Re: Terminal 4 Stormwater Source Control Measures – 100% Design Plan Sets and Operation and Maintenance Plans for Vegetated Infiltration Basins

1. 100% Plan Set and O&M Plan– Basin M Source Control Measure
2. 100% Plan Set and O&M Plan – Basin K1 Source Control Measure
3. Response to DEQ Comments Matrix on 60% Plan Sets

SUBMITTED BY	ROGER ANDERSON	
DESIGN BY	T. TRAN	
DRAWN BY	T. TRAN	
CHECKED BY	J. SHUTE, D. PANKANI	
DATE	FEB 2021	
SHEET NO.	9	TYPE: CD
DRAWING NO.	T4 2021-500	DISC. SHT. NO. C1.01

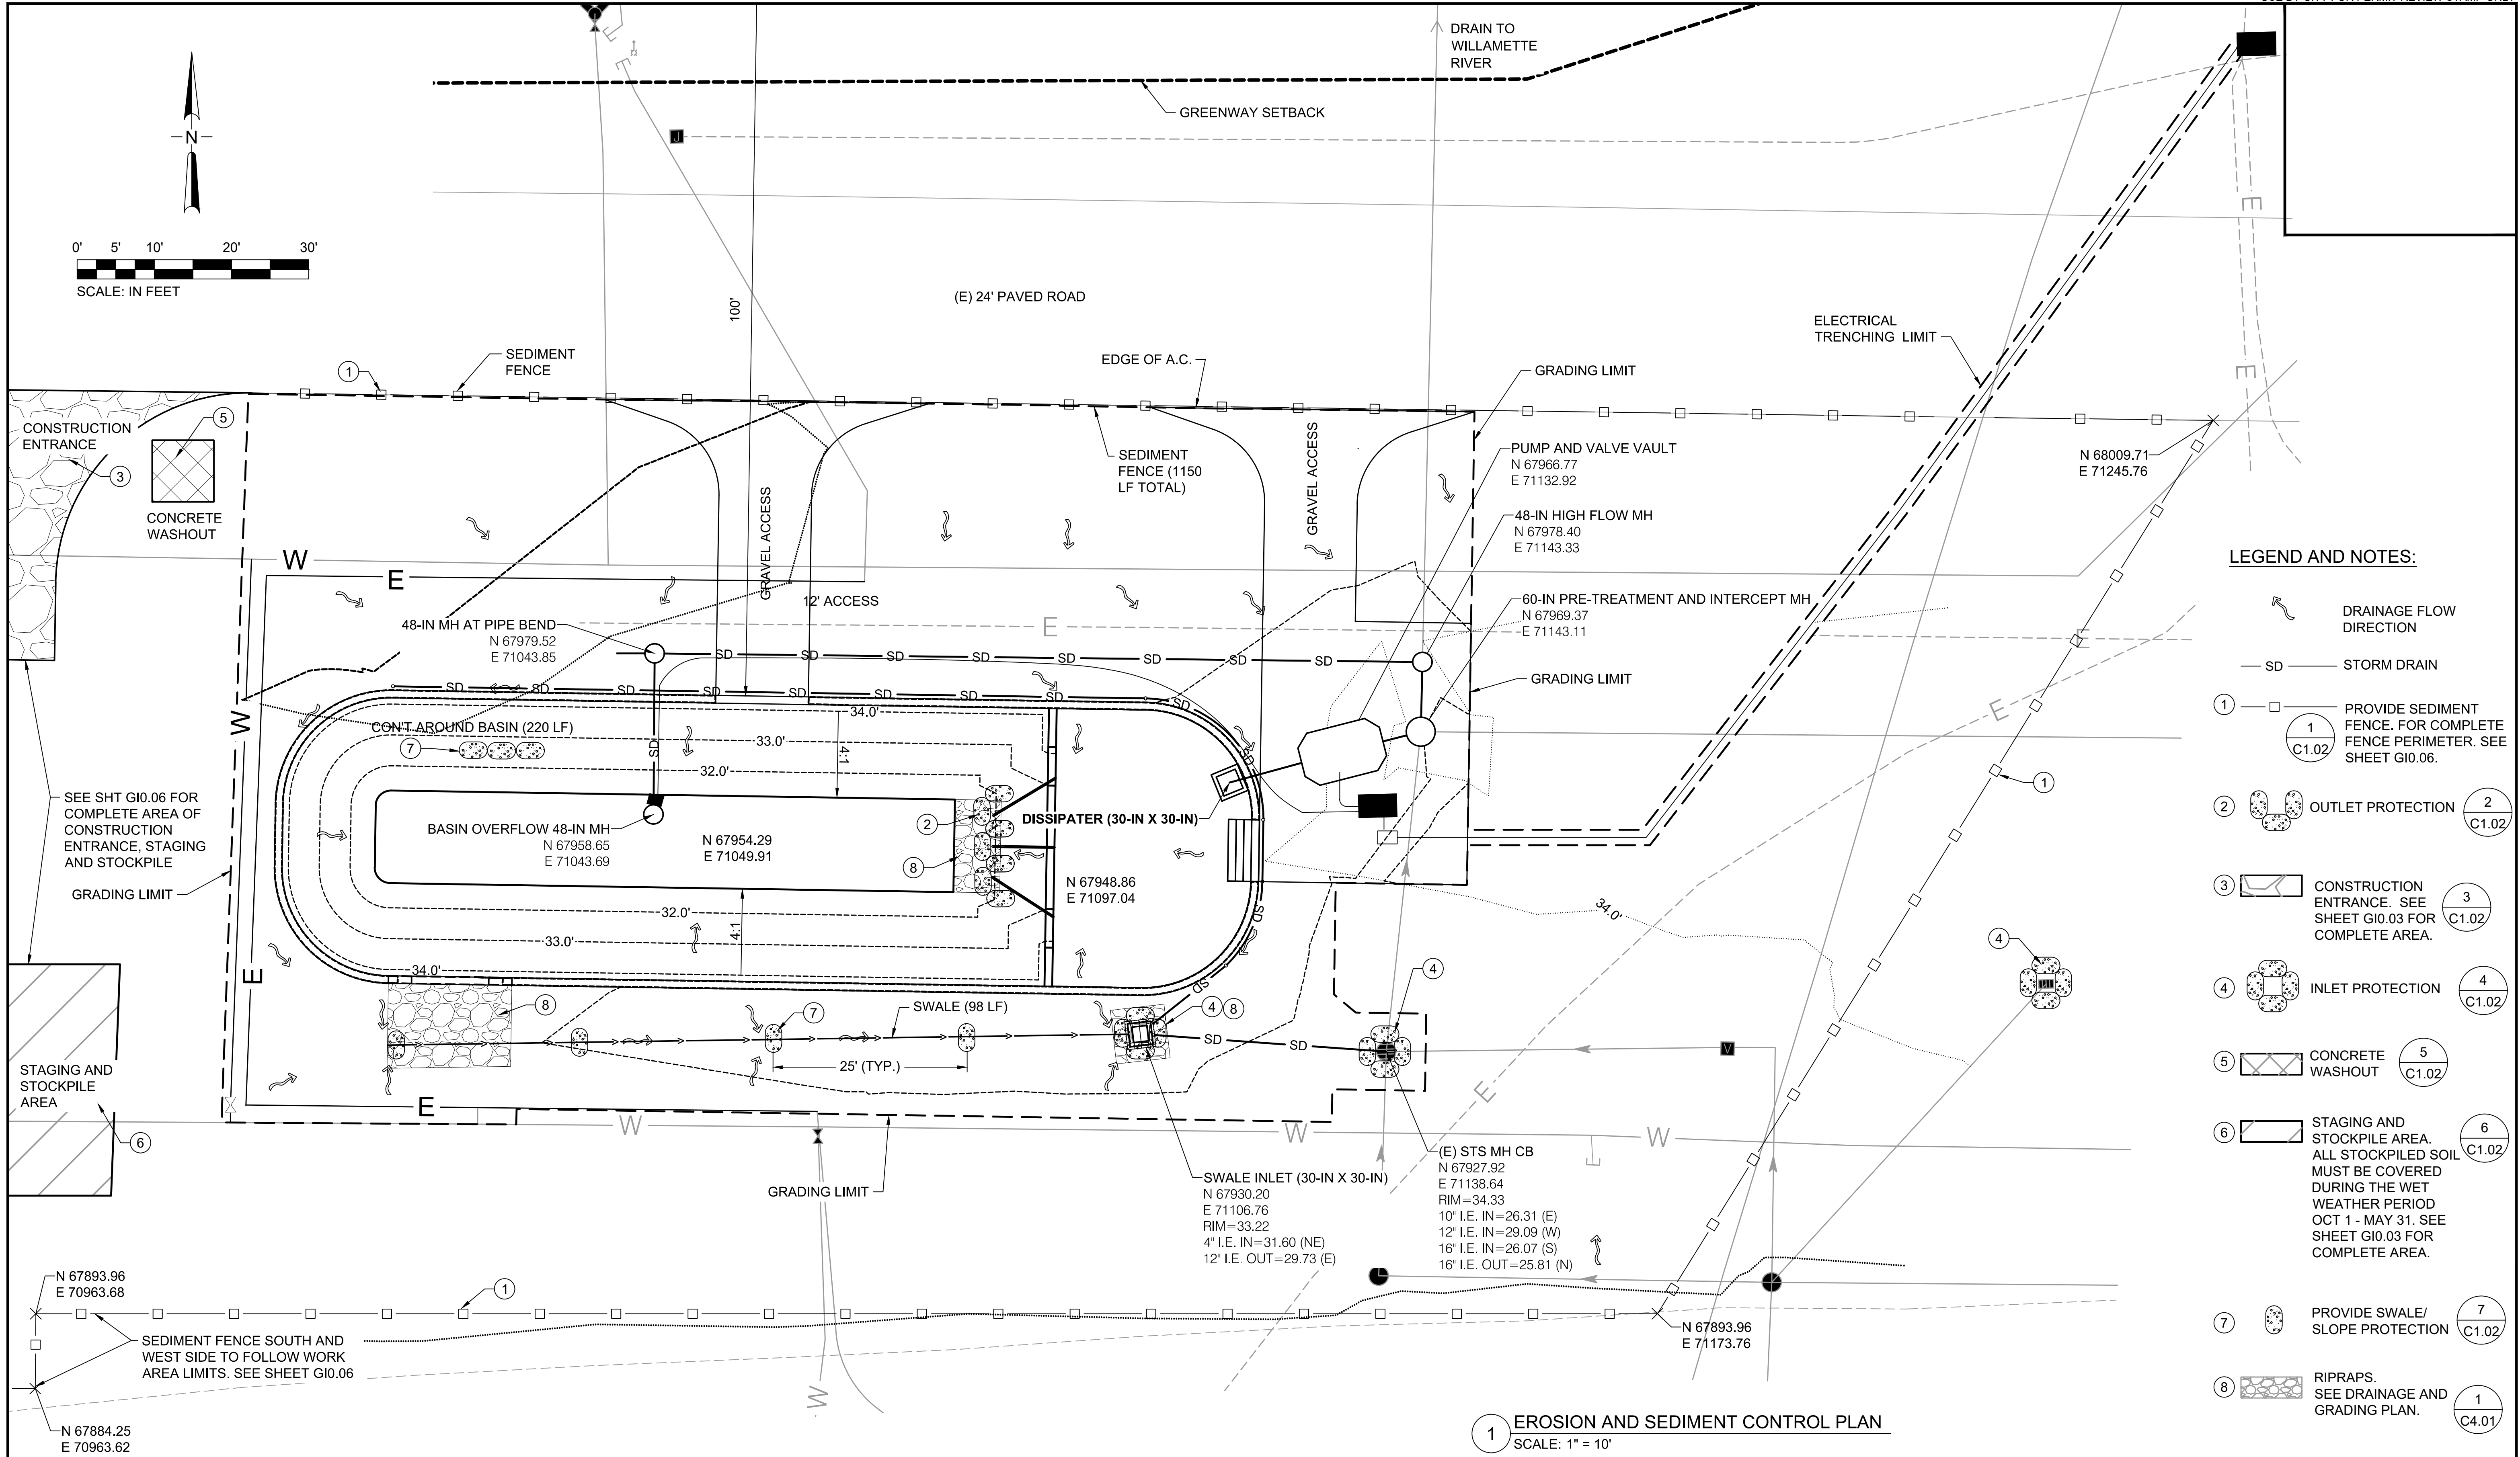
4 - Specific Comments – Basin M	60% Plans Sheet C1.01	4. Sheet C1.01 Erosion and Sediment Control Plan - Please indicate locations for planned soil stockpiles and equipment staging.	Locations of planned temporary soil stockpiles and equipment staging are shown in the 100% design plans (C1.01)
5 - Specific Comments – Basin M	60% Plans Sheets C4.01, C5.01, C6.01	5. DEQ notes that elevations for selected features on Sheet C4.01 Grading Plan, Sheet C5.01 Stormwater System Profile and Sheet C6.01 Civil Details 1 are not consistent. As an example, the bottom elevation of the forebay is shown as 32.19 feet on C4.01 and C5.01 but is shown 32.15 feet on Sheet C6.01. In addition, the force main outlet is shown at an elevation of 33.02 feet (Station 2+1.02) on Sheet C4.01 but as 32.38 feet on Sheet C5.01. If the discrepancies are due to different survey stationing it is not clear from the information provided. Please clarify or correct as appropriate.	The discrepancies noted have been corrected in the 100% design as follows: • <i>Bottom elevation of forebay: 32.19’ (confirmed on sheets C4.01, C5.01, C6.01)</i> • <i>Force main outlet IE: 33.02’ (confirmed on C4.01, C5.01)</i>
